35-DR-2015

**Case Reference No: 35-DR-2015, The Holiday**

RE: 35-DR-2015  
The Holiday

## Cover Letter Response to Staff Review Comments

2  
002 Site Wall Elevations  
Scale: 1/2" = 1'-0"

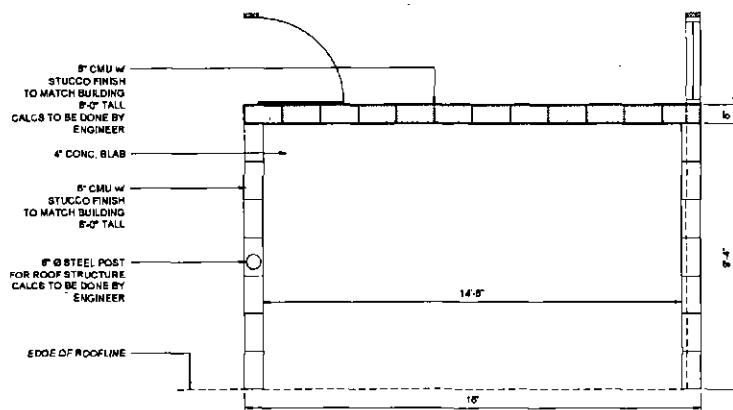
23. The Site Wall Elevations, Detail 2/002, appear to illustrate concrete masonry units that are laid on the side to expose the open cell within the unit. Please revise the detail for the perimeter and site walls so that they will be constructed with 6 or 8 inch wide concrete masonry blocks, 8 inches wide brick, stone, concrete, or a similar solid and durable material to match the building. Stucco and paint the surface of concrete block walls to match the on-site buildings unless they are split-faced, grid or similar decorative types of block. Please refer to the Design Standards & Policies Manual, Section 2-1.401.5.

23. The Site Wall Elevations, Detail 2/002, appear to illustrate concrete masonry units that are laid on the side to expose the open cell within the unit. Please revise the detail for the perimeter and site walls so that they will be constructed with 6 or 8 inch wide concrete masonry blocks, 8 inches wide brick, stone, concrete, or a similar solid and durable material to match the building. Stucco and paint the surface of concrete block walls to match the on-site buildings unless they are split-faced, **grid** or similar decorative types of block. Please refer to the Design Standards & Policies Manual, Section 2-1.401.5. No change has been made. The boundary wall

4  
002 Refuse Enclosure Plan  
Scale: 1/2" = 1'-0"

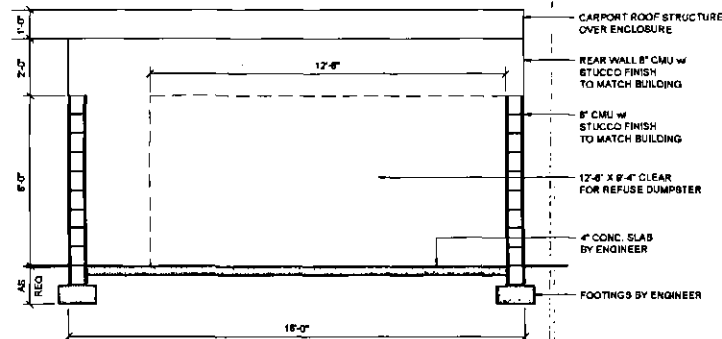
18. Please revise the Refuse Enclosure Plan, Detail 4/002, so that the proposed roof is eliminated above the enclosure. Please refer to the Design Standards & Policies Manual, Section 2-1.804.

18. Please revise the Refuse Enclosure Plan, Detail 4/002, so that the proposed roof is eliminated above the enclosure. Please refer to the Design Standards & Policies Manual, Section 2-1.804. No correction has been made. In conversation with Joe Morris via phone on September 24th, a roof over the proposed roll-out refuse enclosure is completely acceptable.

7  
002 Bench/Bicycle Rack Detail  
Scale: 1/2" = 1'-0"

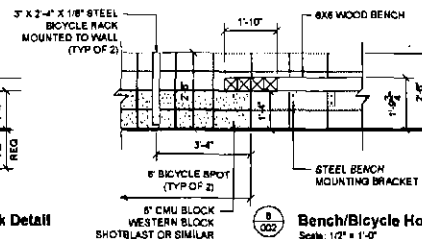
40. Per Transportation Department review, bike racks should conform to City of Scottsdale (COS) Bike Rack Standard Detail #2285, per the Design Standards & Policies Manual, Section 2.1-808.

40. Per Transportation Department review, bike racks should conform to City of Scottsdale (COS) Bike Rack Standard Detail #2285, per the Design Standards & Policies Manual, Section 2.1-808. **The proposed design in this resubmitted package has been approved by the Scottsdale Transportation Department via email from Greg Davies on September 28, 2015.**

I've attached a Site Plan and Details (See detail 7 and 8) on what we are hoping to do in means of sufficing bicycle parking. Please feel free to call me sometime today at 603.401.1548 to discuss this proposed design.
